REV.
D

AS91101™

BOLT, MACHINE - DOUBLE HEXAGON EXTENDED
WASHER HEAD, CLOSE TOLERANCE SHANK,
UNS S66286, 130 KSI MIN, .1900-32 UNJF-3A

FIGURE 1 - BOLT

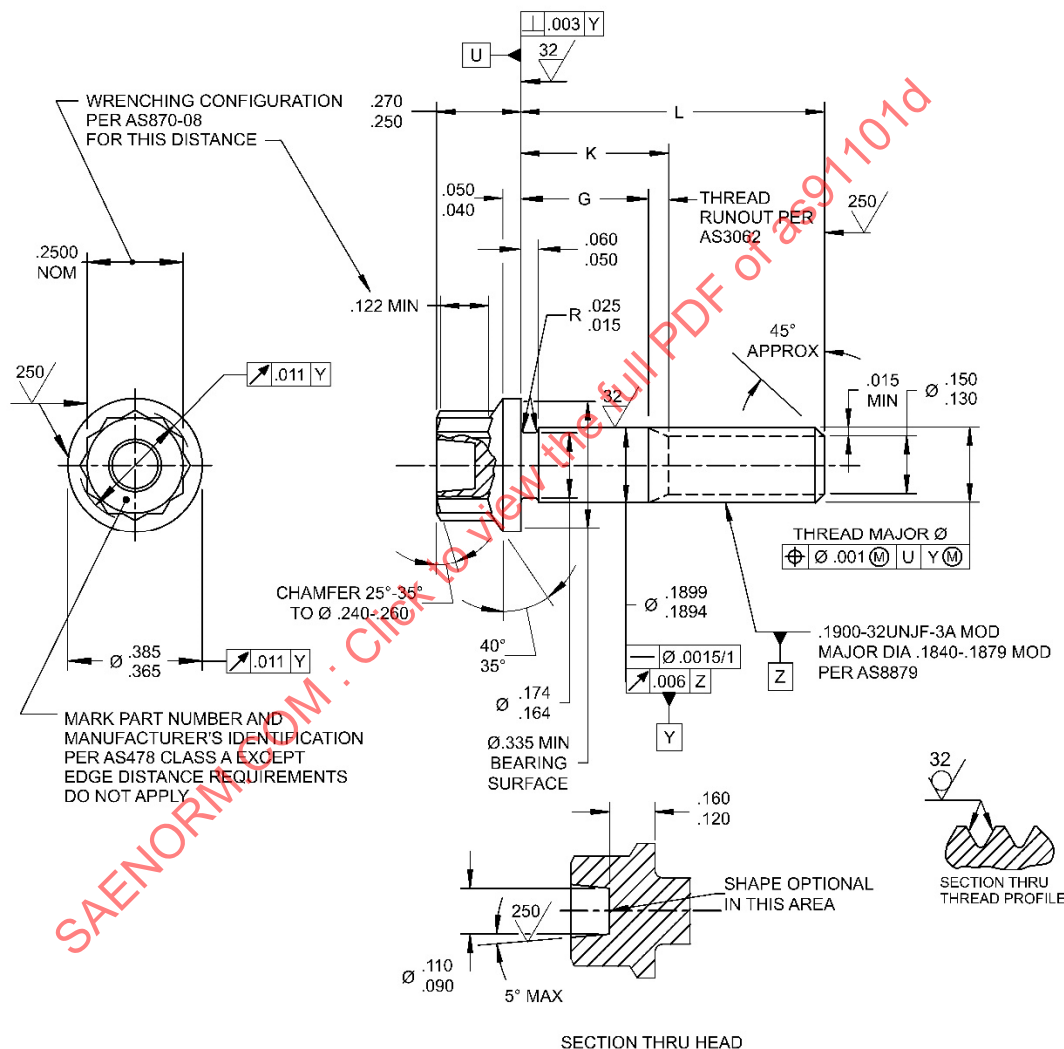
UPDATE TO ASME Y14.5-2018. DELETE RUNOUT REQUIREMENT ON SHANK TO DATUM M AND ADD POSITION TOLERANCE ON MAJOR DIA (ADD DATUM U ON BEARING FACE) PER AS1132. REVISE LEAD THREAD CHAMFER TO AS1132. REVISE LIGHTENING HOLE CONFIGURATION TO AS1132. NOTE 1 - ADD "COMPOSITION SIMILAR TO" TO UNS.
